Contract #: 04-0120F4Cty: SF/ALA Rte: 80 PM: 13.2/13.9File #: 69.25B**QUALITY ASSURANCE -- NON-CONFORMANCE REPORT****Location:** Changxing Island, Shanghai, P. R. China**Report No:** NCR-000491**Prime Contractor:** American Bridge/Fluor Enterprises, a JV**Date:** 25-Oct-2009**Submitting Contractor:** Zhenhua Port Machinery Company, Ltd (ZPMC), Changxing Island**NCR #:** ZPMC-0464**Type of problem:**

Reference Description: Missed MT Indications by QC on OBG Segment 6AW DP**Description of Non-Conformance:**

Job Name: SAS Superstructure

Subject: NCR No. ZPMC-0464

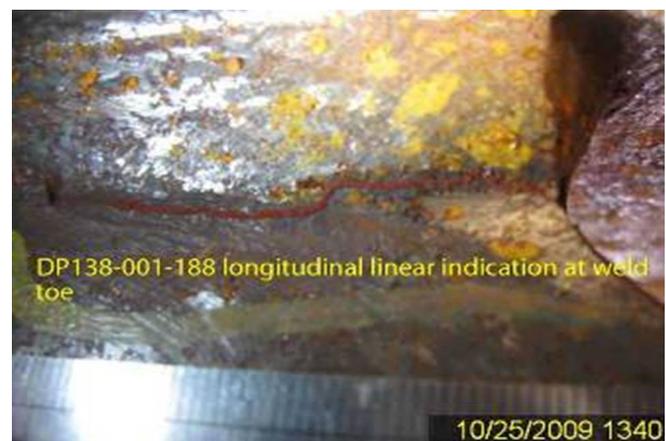
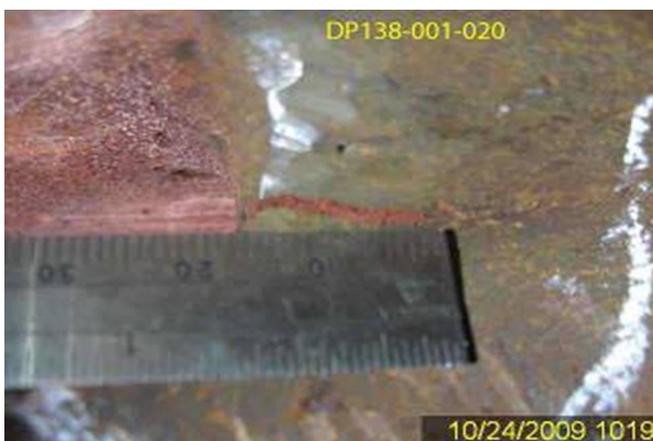
During a random Magnetic Particle (MT) verification (October 25, 2009), of welds at OBG Segment 6AW, Caltrans Quality Assurance (QA) Inspector observed two (2) Longitudinal Cracks on the Deck Panel Diaphragm to Deck Panel fillet welds measuring 40 mm and 15 mm in length. These welds were identified as DP138-001-187 and 188. ZPMC had previously MT tested and accepted these welds mentioned above.

During random MT verification (October 24, 2009) of OBG Segment 6AW, Caltrans QA observed two (2) linear Longitudinal Cracks on Deck Panel Diaphragm to Deck Panel fillet welds measuring 15mm in length each on welds DP138-001-019 and 020. These welds were previously tested and accepted by ZPMC QC MT.

Submit a repair procedure to the engineer for approval. Provide training for the MT technicians and submit training results indicating competency.

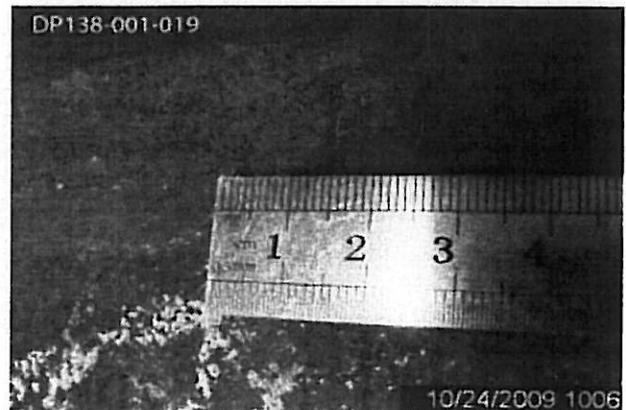
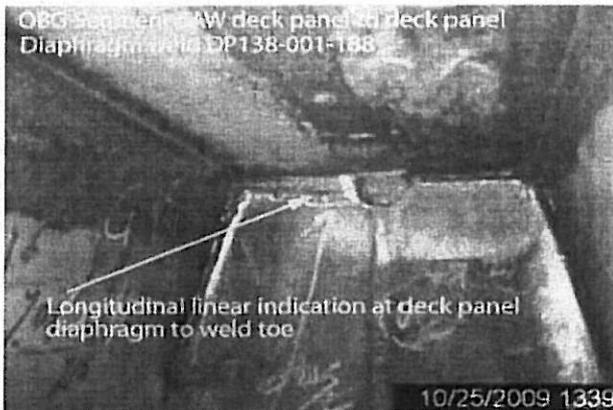
During a random Magnetic Particle (MT) verification (October 25, 2009), of welds at OBG Segment 6AW, Caltrans Quality Assurance (QA) Inspector observed two (2) Longitudinal Cracks on the Deck Panel Diaphragm to Deck Panel fillet welds measuring 40 mm and 15 mm in length. These welds were identified as DP138-001-187 and 188. ZPMC had previously MT tested and accepted these welds mentioned above.

During random MT verification (October 24, 2009) of OBG Segment 6AW, Caltrans QA observed two (2) linear Longitudinal Cracks on Deck Panel Diaphragm to Deck Panel fillet welds measuring 15mm in length each on welds DP138-001-019 and 020. These welds were previously tested and accepted by ZPMC QC MT.

Draft of Welding Discontinuity:

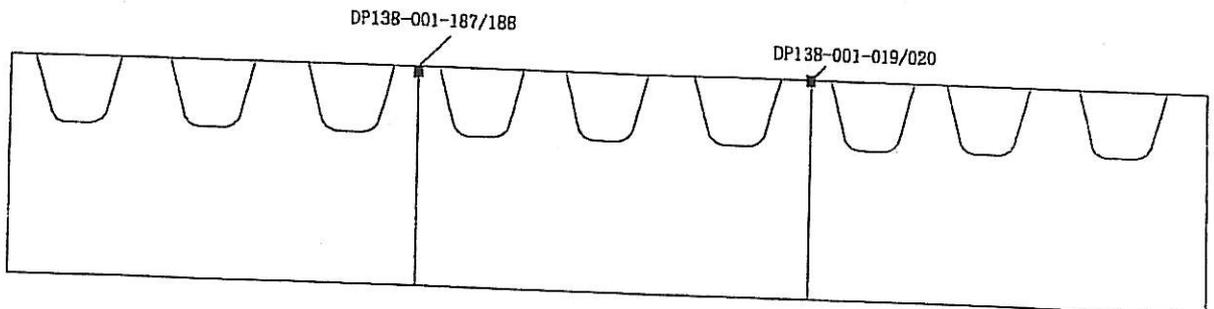
- One longitudinal crack was found by use of MT on DP138-001-187
- One longitudinal crack was found by use of MT on DP138-001-188
- One longitudinal crack was found by use of MT on DP138-001-019
- One longitudinal crack was found by use of MT on DP138-001-020

1. 火焰加热时, 水汽没有完全的去掉或者这个区域预热不够;
1. Moisture wasn't completely removed during drying operation (preheating) or the area wasn't preheated sufficiently.

1. QC and a Lead CWI shall be present, direct and supervise all grinding and welding operations during this repair to ensure the repair is per the disposition requirements

2. QC and a Lead CWI shall have an approved copy of the CWR in hand prior to the repair.
3. Remove paint $\geq 25\text{mm}$ in all direction of HAZ prior to MT.

4. Clean the excavation area of all loose debris including MT powder. Preheat to 65° C before removing cracks by grinding, repair area shall extend a minimum of 50mm beyond each end of single crack repairs.

5. If base metal is damaged by grinding, the damaged area shall be ground clean prior to performing weld repair. If gap $> 5\text{mm}$ is found during or after grinding, comply with the notification on changing fillet weld to CJP which is submitted for Engineer's review and approval form.
